CITY OF ALBUQUERQUE

December 6, 2022

Re: Dollar General
7500 Universe Blvd. NE
Traffic Circulation Layout
Engineer's/Architect's Stamp XX-XX-XX (C09-D017)

SITE PLAN
SCALE: 1"=20'

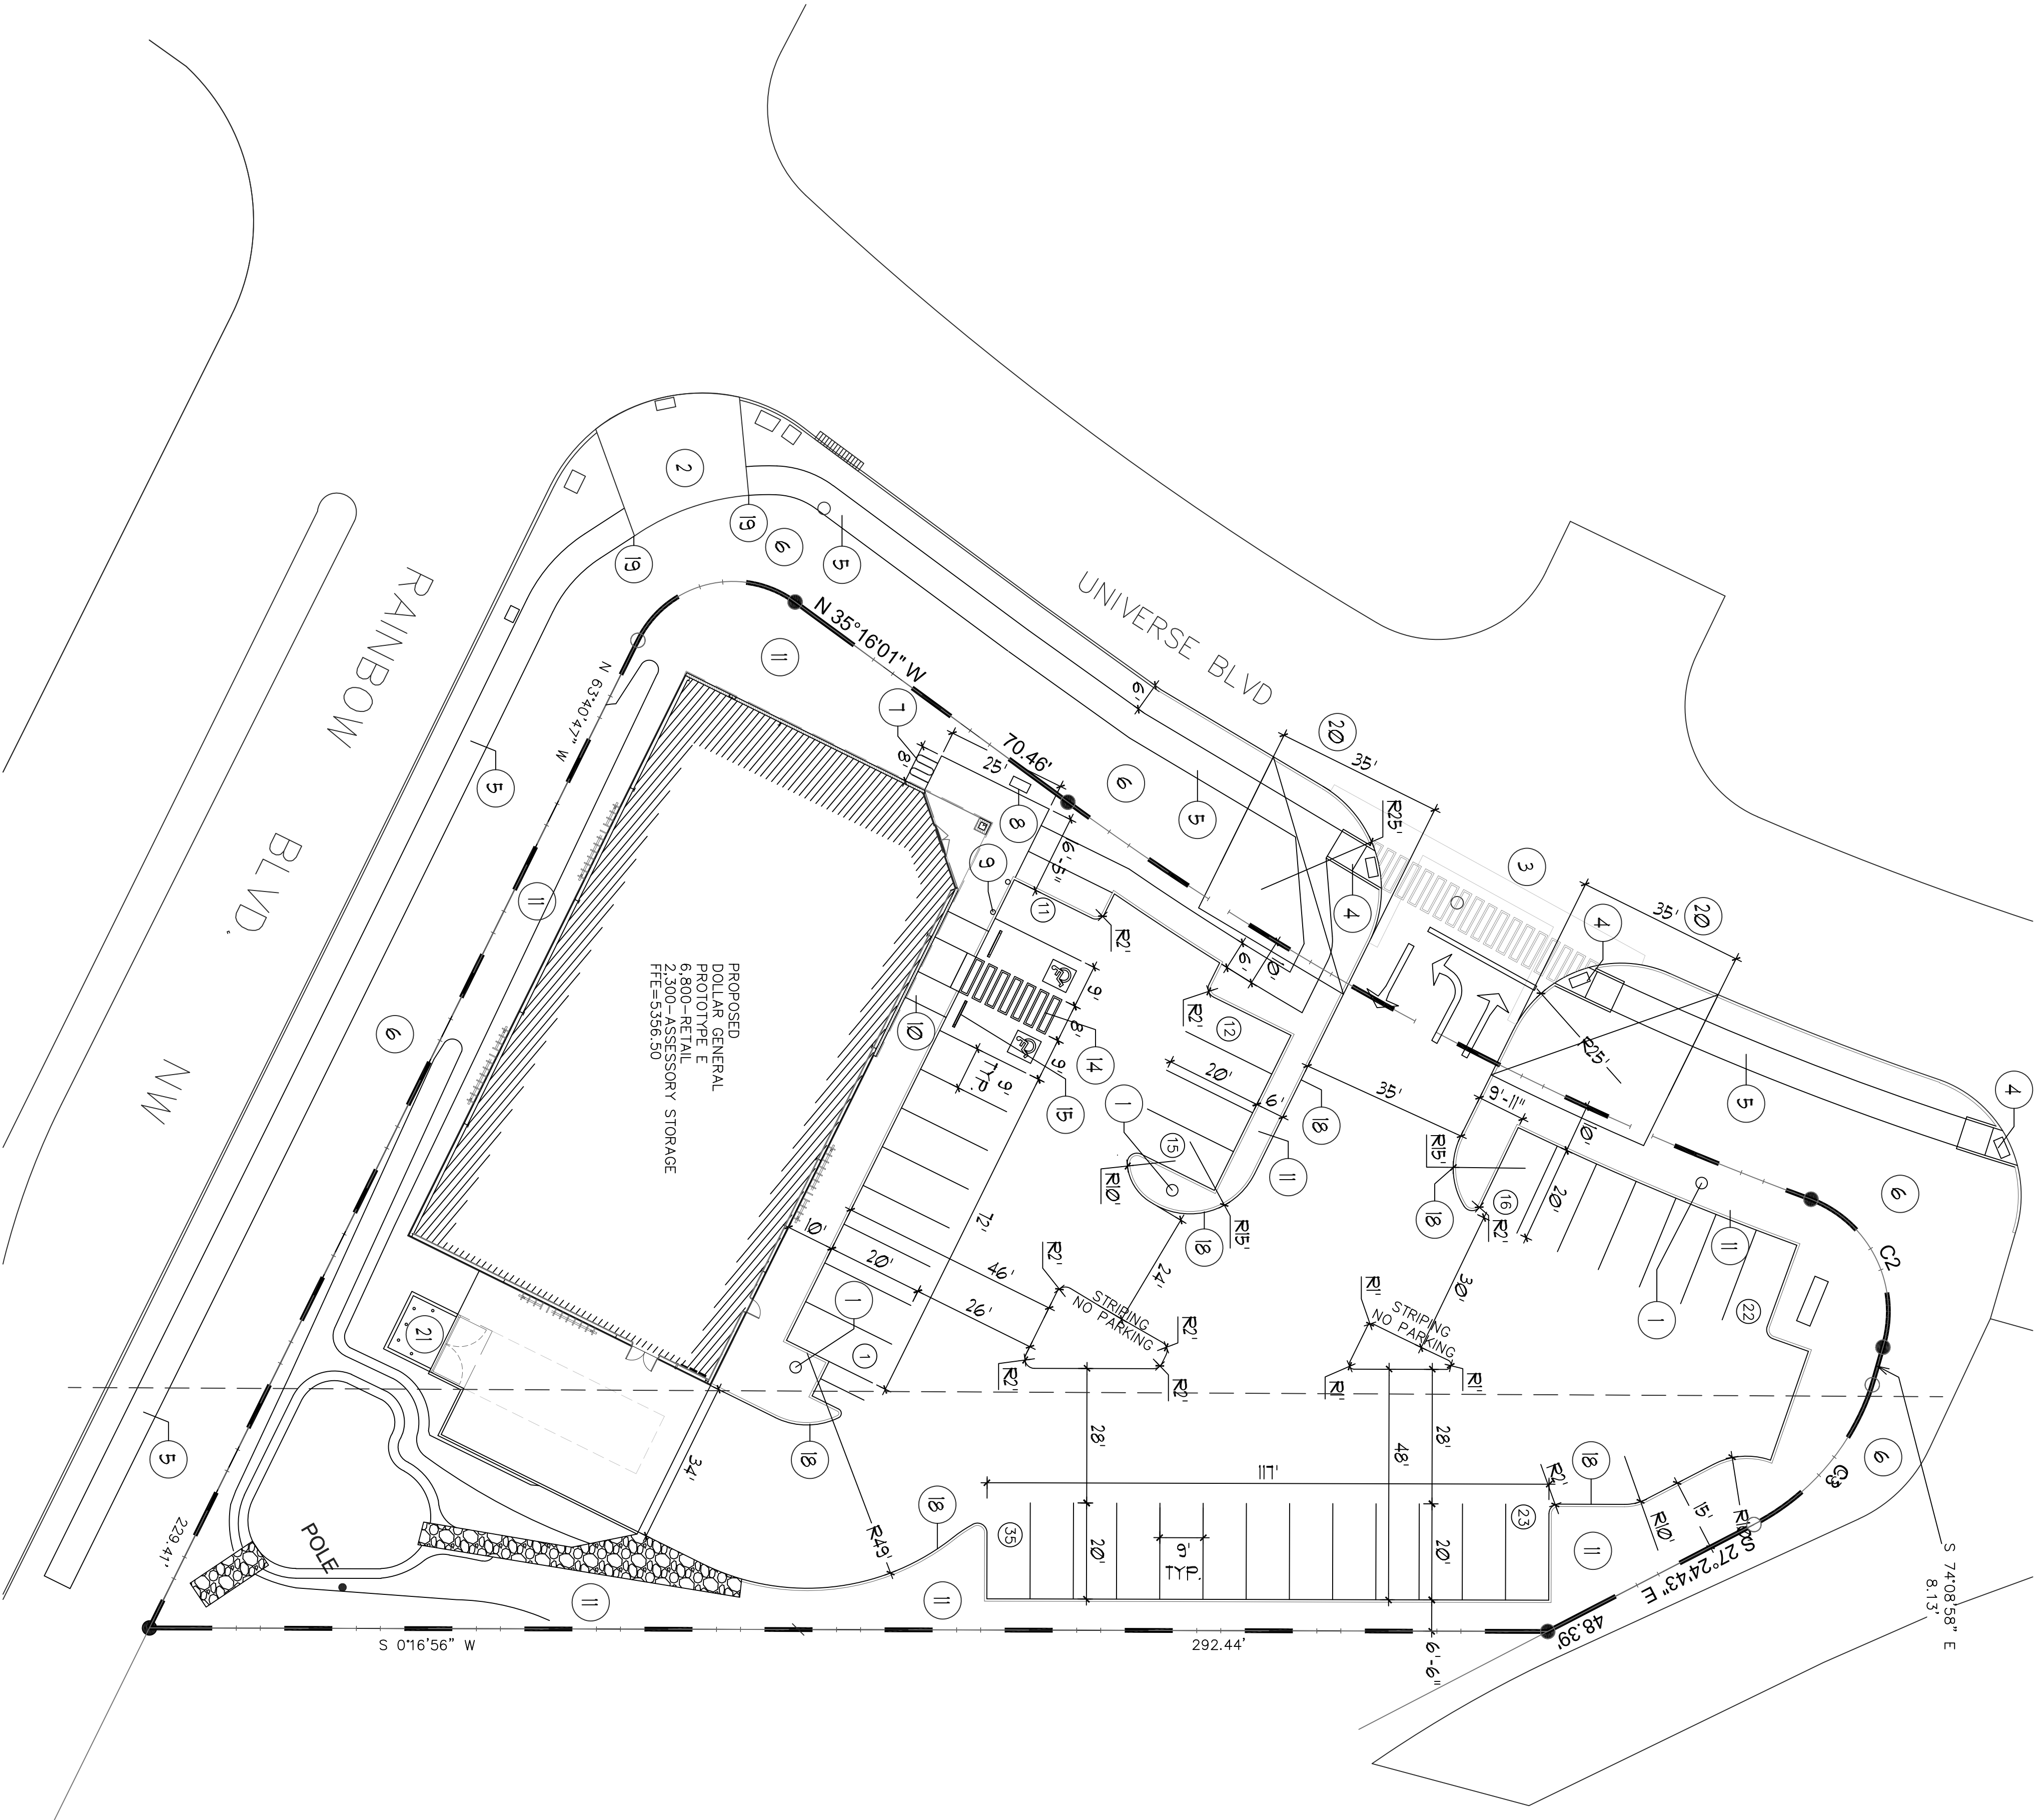
1. The traffic circulation layout must be stamped, signed, and dated by an engineer or architect licensed in the state of New Mexico.
2. Identify all existing access easements and rights of way width dimensions.

3. Identify the right of way width, medians, curb cuts, and street widths on Universe Blvd. and on Rainbow Blvd.
4. ADA curb ramp at the corner of Universe Blvd. and Rainbow Blvd. must be updated to current standards and have truncated domes installed.

5. Motorcycle parking spaces shall be designated by its own conspicuously posted upright sign, either free-standing or wall mounted per the zoning code.

6. The pavement marking "MC" should be shown in the opposite direction for motorcycles entering the parking space.
7. A 5 ft. keyway is required for dead-end parking aisles.

8. Please provide the ADA landing area dimension.
9. Please provide a copy of Fire Marshal and Solid Waste approval.
10. Show the clear sight triangle and add the following note to the plan: "Landscaping and signage will not interfere with clear sight requirements. Therefore, signs, walls, trees, and shrubbery between 3 and 8 feet tall (as measured from the gutter pan) will not be acceptable in the clear sight triangle.

11. Please specify the City Standard Drawing Number when applicable.
12. Work within the public right of way requires a work order with DRC approved plans.

13. Please add a note on the plan stating "All improvements located in the Right of Way must be included on the work order."
14. Please provide a letter of response for all comments given.
